PLANNING BOARD REPORT PORTLAND, MAINE

Five-Unit Condominium
24 St. Lawrence Street
Level III Site Plan and Subdivision
2017-242
Kelly and Walter Williams, Applicant

Submitted to: Portland Planning Board:
Public Hearing Date: July 27, 2018

Prepared by: Shukria Wiar, Planner
Date: July 20, 2018

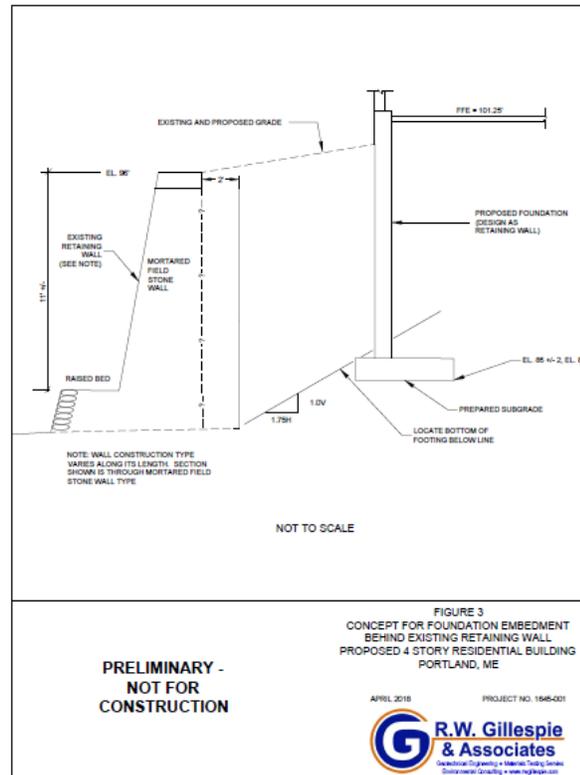
There is one existing, mature tree within the right of way. Originally, this tree was proposed to be removed to accommodate the new driveway entrance. While the final location of the curb cut does not impact the existing tree, the applicant is still proposing to remove the tree. The staff is recommending that efforts be made to preserve the street tree. The staff is recommending the following condition of approval:

The site plan shall be revised to show retaining the existing tree and that the applicant and contractor shall submit documentation for review and approval by the City Arborist and Planning Authority that addresses preserving the tree and complies with the standards of the Technical Manual standard, section 4.3 Preservation of Existing Vegetation.

If the existing tree cannot be saved per the decision of the City Arborist, then the applicant shall replace the street tree. Due to site restrictions, the remaining three street trees cannot be planted on the site. Therefore, the applicant will need to contribute to the City's Tree Fund for the three trees, which is a total of \$1,200.
